ERC0378 – Accelerating Smart Meter Deployment Draft Rule

PLUS ES welcomes the opportunity to provide feedback to the Australian Energy Market Commission's (**AEMC**) Draft Rule Determination - Accelerating Smart Meter Deployment Draft Rule – ERC0378.

Figure 1 – LMRP Date available via MSATS

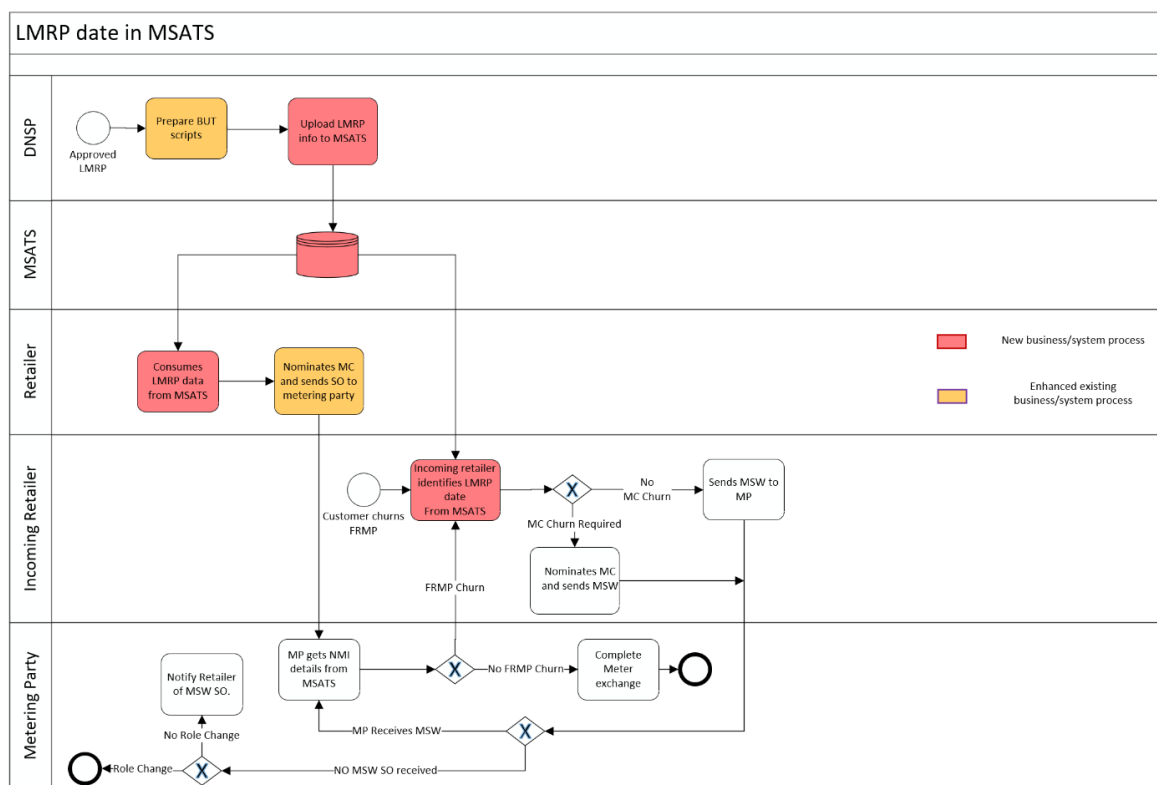
- The operational efficiency of having the LMRP detail transparent to participants in MSATS. Using the existing Blind Update Tool (**BUT**²), as discussed in industry forums, would deliver a seamless and efficient process (Figure 1). Participants would have to build for a new field in MSATS, but this cost would be a one-time cost compared to the ongoing operational costs for the alternative process. The cost to introduce this field in MSATS would also be incremental as there are other fields required to be developed for MSATS as a result of the proposed Rules.

Figure 2 – LMRP date available via B2B Communications

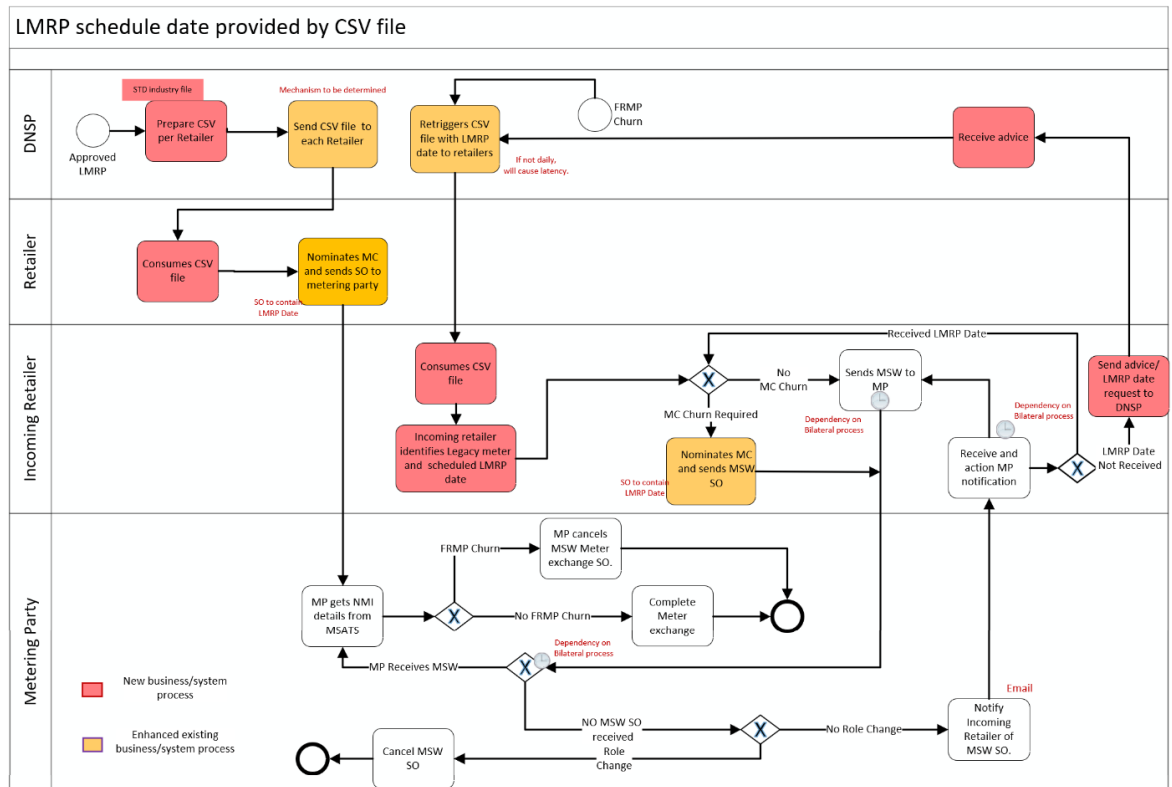
The alternative, as shown in Figure 2, would introduce a delay in the provisioning of relevant information, requiring additional administrative burden and consequently costs on participants and adding unnecessary dependencies on other parties to provision information which would otherwise be available to relevant parties directly via MSATS. See below comparative high-level flows. Both Figure 1 and 2 depict high-level process flows that illustrate the general

Figure 3 – Defect Enumeration in MSATS

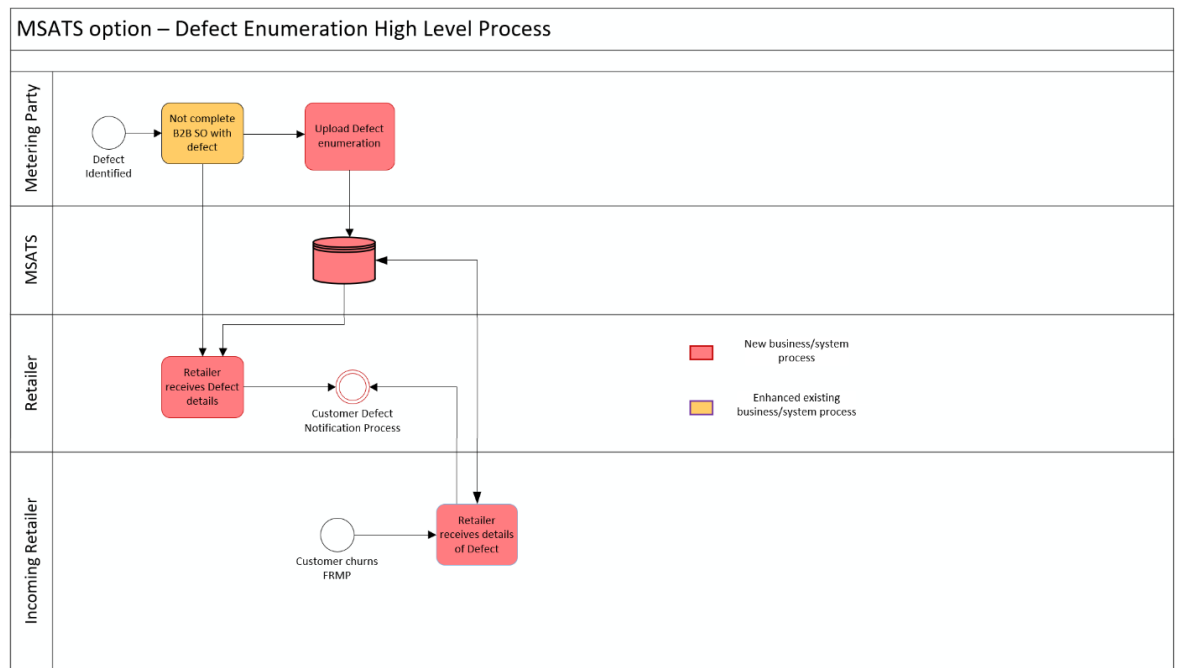
- Defect flag versus defect enumeration⁷ in MSATS – Providing the Retailer and customer with the type of defect identified on site is crucial in building transparency. Sharing at a minimum, the type of defect with the customer⁸ and the recommended course of action, will help to alleviate their concerns and potentially minimise the volume of subsequent customer queries. PLUS ES recommends that having enumerations in MSATS would deliver a seamless, overall cost-efficient process for the Retailer, incoming Retailer⁹ or any party who has a financial interest in the NMI, to gain access to the defect type, irrespective if the metering party who identified the defect has churned¹⁰ or not.

With the inclusion of the defect enumeration in MSATS, the defect flag would not be required, as a populated enumeration would suffice to indicate there is a defect on the site whilst providing a high-level detail of what the defect is. The following indicative enumerations were proposed to be included in MSATS:

Figure 4 – Defect details maintained by metering party who identified defect.

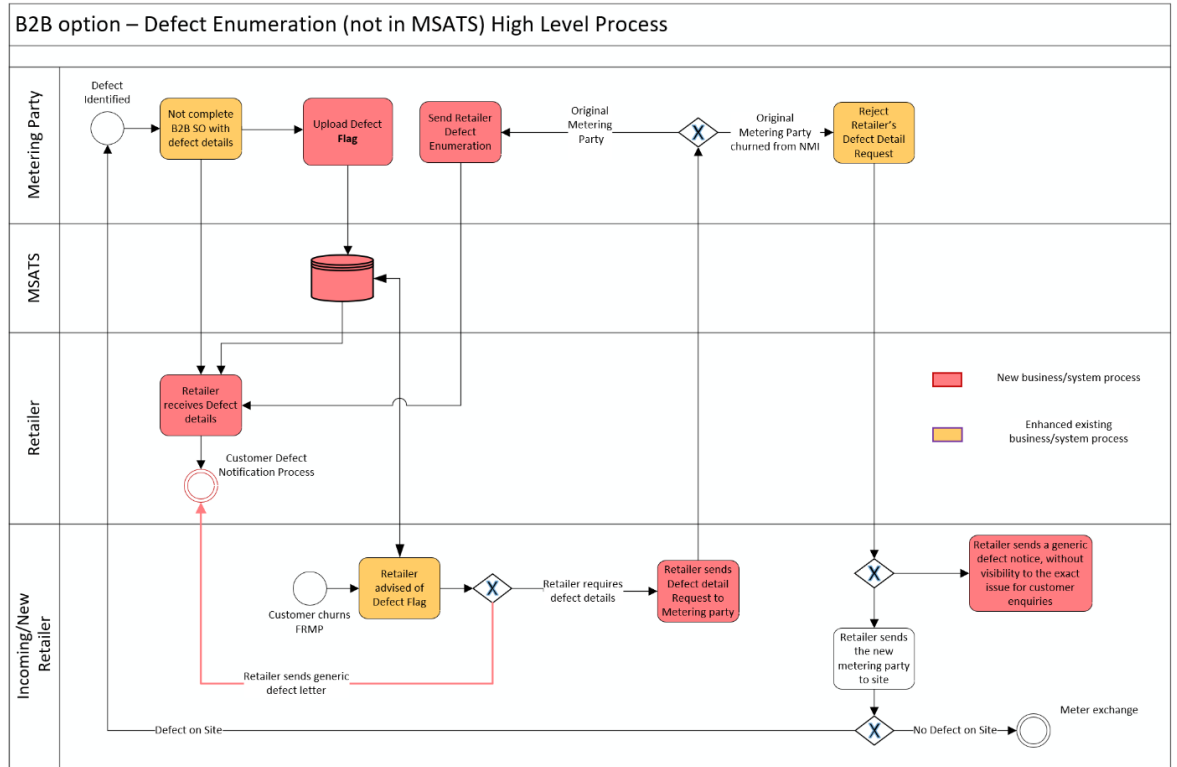
The alternative would introduce a process with latency in the communication of relevant information, requiring additional administrative burden and consequently costs on participants and adding unnecessary dependencies on other parties to provision information which would otherwise be available to relevant parties directly via MSATS. It also places constraints on the MC provisioning the details once they have been churned out of the role for that NMI due to no longer having access to confirm if the party requesting the details is entitled to that information. See below comparative high-level flows.

Both Figure 3 and 4 depict high-level process flows that illustrate the general steps involved in a specific activity. While the activities and tasks may vary among participants, the non-

MSATS option introduces additional effort, and by extension operational cost. This impact is consistent across all parties involved. Additionally, it highlights that it creates a variation in the process dependent on the Retailer.
